HISTORIC AND DESIGN REVIEW COMMISSION

July 17, 2019

HDRC CASE NO: 2019-350
ADDRESS: 742 DENVER BLVD
LEGAL DESCRIPTION: NCB 1633 BLK 35 LOT N 89.5 FT OF 1-2-3 & N 89.5 FT OF E 12.5 FT OF 4
ZONING: RM-4,HL
CITY COUNCIL DIST.: 2
LANDMARK: Church
APPLICANT: Jose Juarez
OWNER: EL SALVADOR ASSEMBLY OF GOD
TYPE OF WORK: Construction of an ADA ramp
APPLICATION RECEIVED: June 10, 2019
60-DAY REVIEW: August 09, 2019
CASE MANAGER: Stephanie Phillips
REQUEST:

The applicant is requesting a Certificate of Appropriateness for approval to construct an ADA ramp on the side of the front entrance of the church.

EXISTING FLOOR PLAN

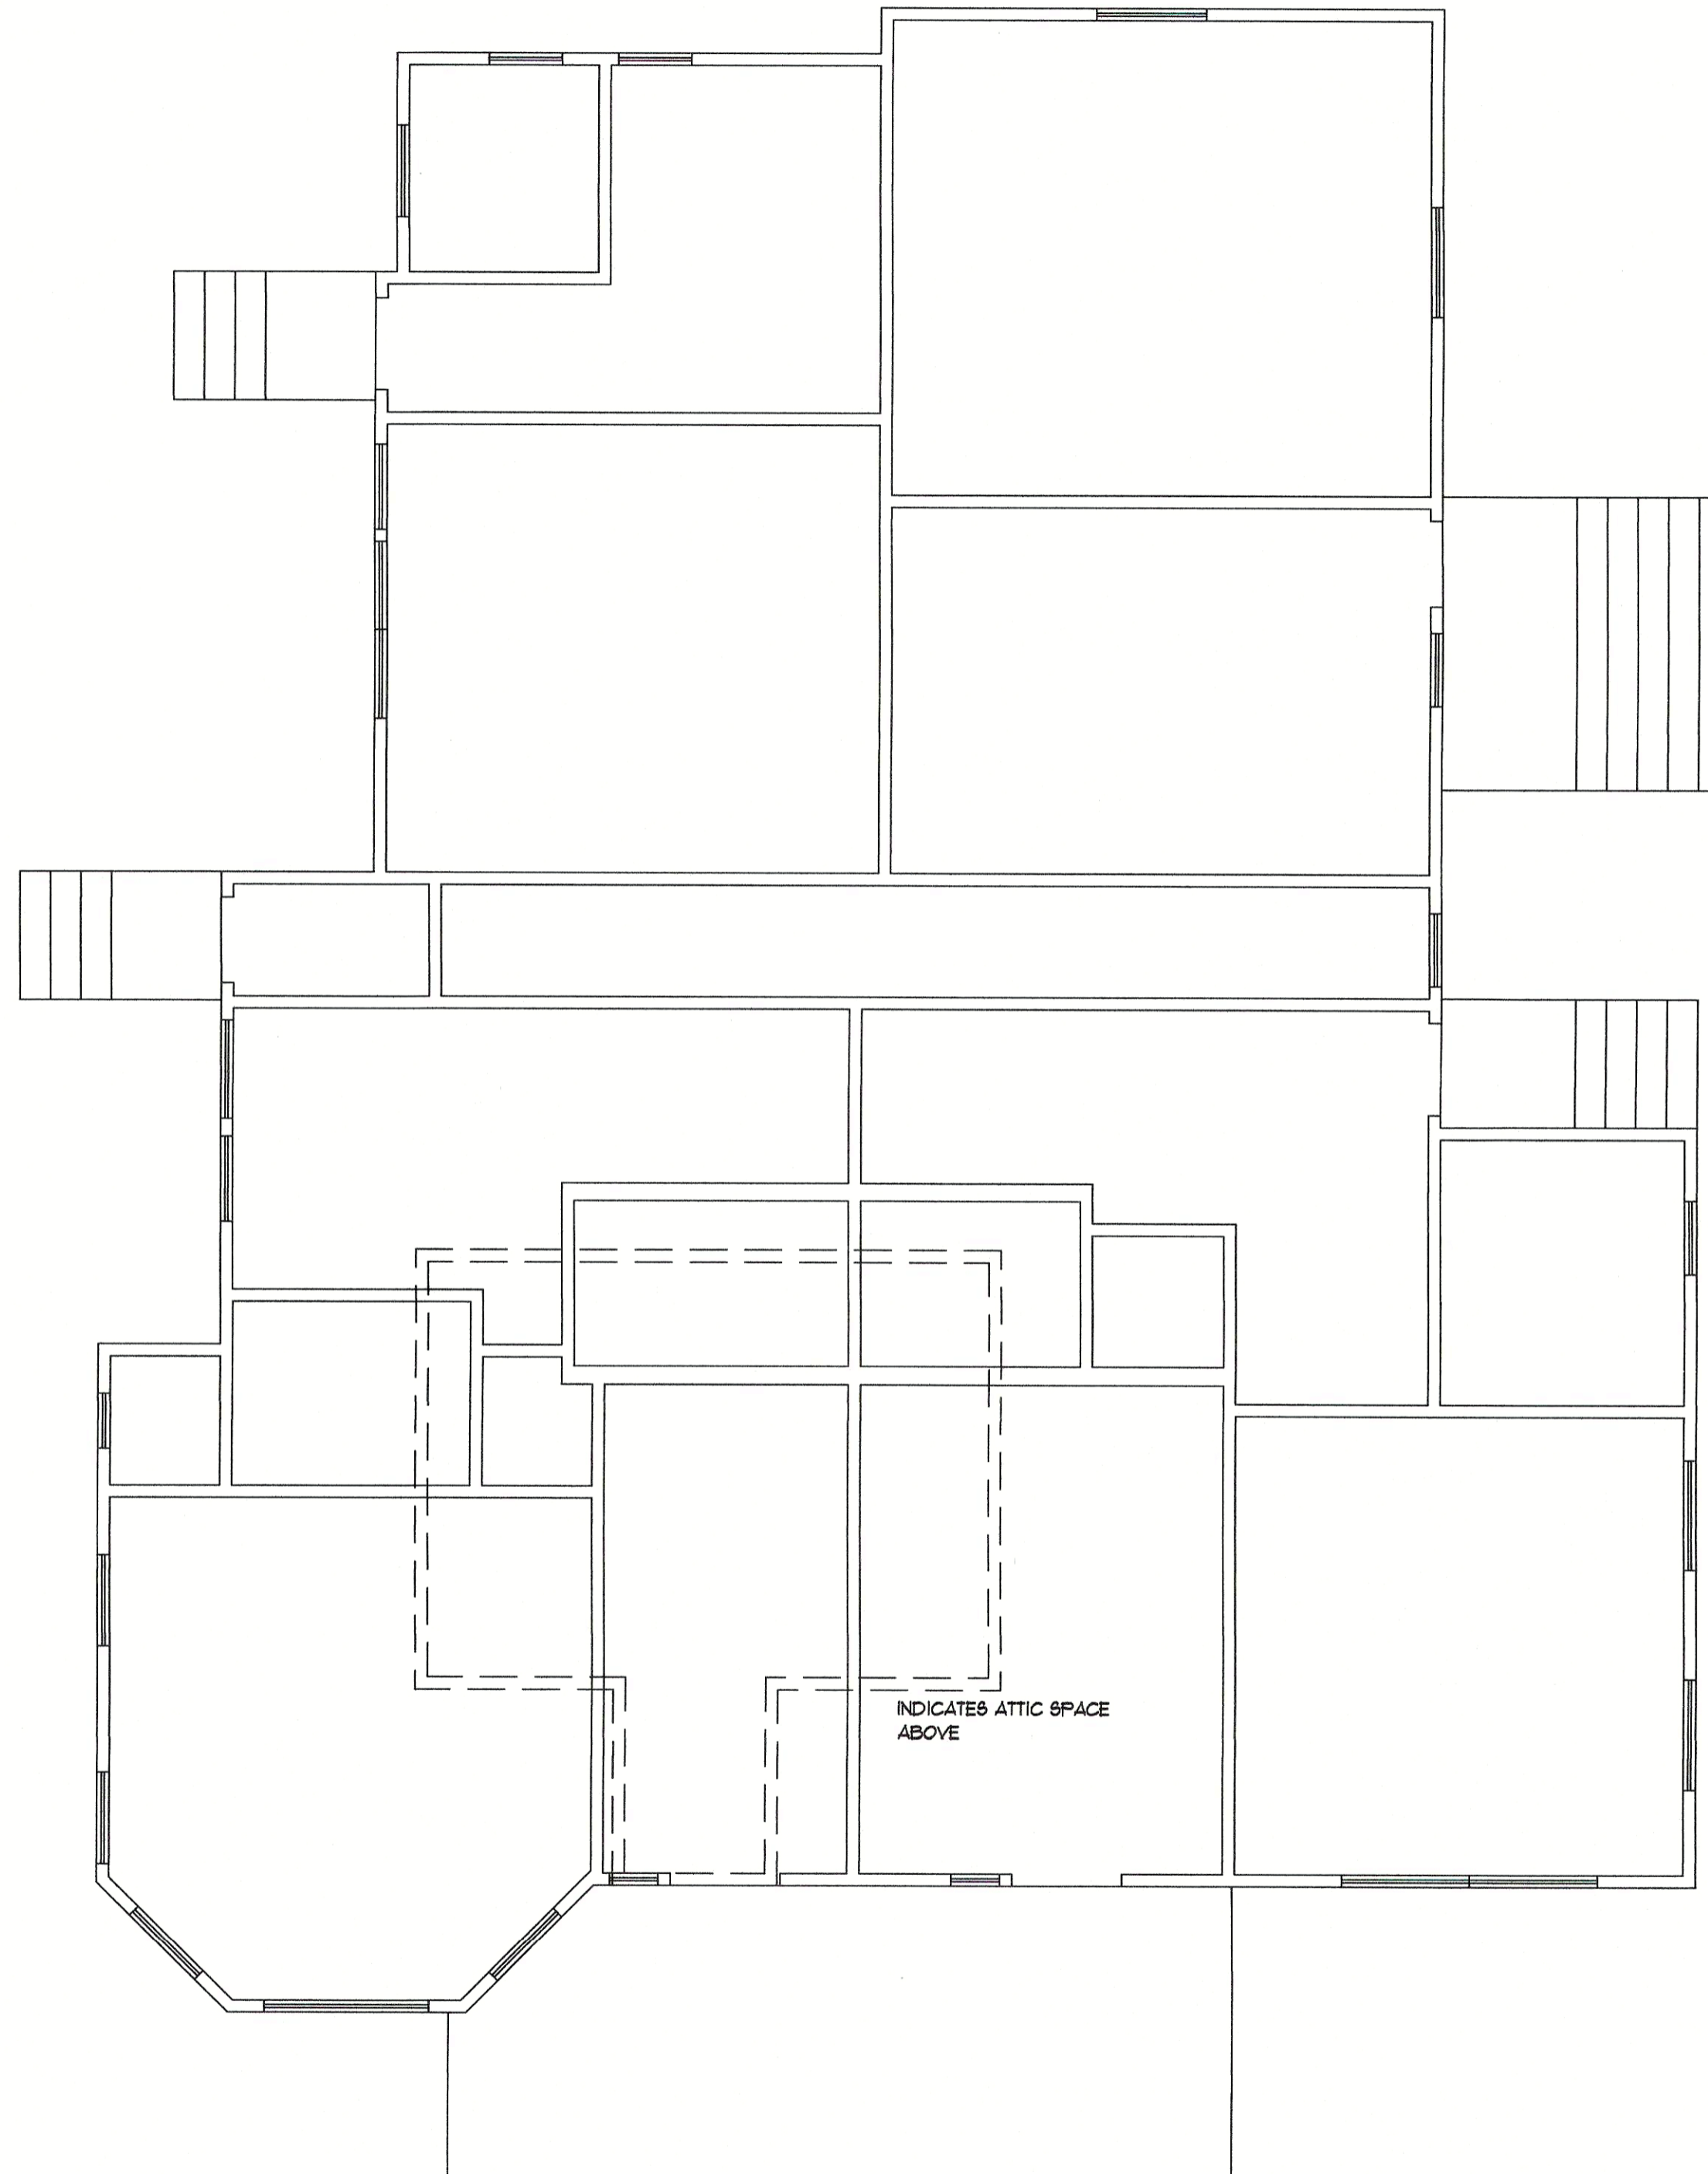
- b. ADA RAMP – The applicant has proposed to construct an ADA ramp to the south of the main entrance. The main entrance is located on the east façade along St Anthony Ave, which is not the primary façade fronting Denver Blvd. The entrance is inset from the eastern wing addition and obscured from view along Denver Blvd. The ramp will feature several switchbacks and landings and will be constructed primarily of wood. According to the Historic Design Guidelines for Site Elements, new ramps should be designed to complement the historic character of the building and be visually unobtrusive to minimize impact, especially if visible from the public right-of-way. ADA elements should be screened with appropriate landscaping materials. Staff finds that while the scale of the ramp is visually large due to the height of the door and the switchbacks and landing requirements, the location of the ramp does not detract from the structure, especially the primary façade along Denver Blvd. Staff finds that the ramp should be screened with landscaping from the public right-of-way along St Anthony Ave to further comply with the Guidelines.

- i. That the applicant screens the ramp from St Anthony Ave with landscaping. The applicant is required to provide a landscaping plan to staff for review and approval prior to the issuance of a Certificate of Appropriateness.
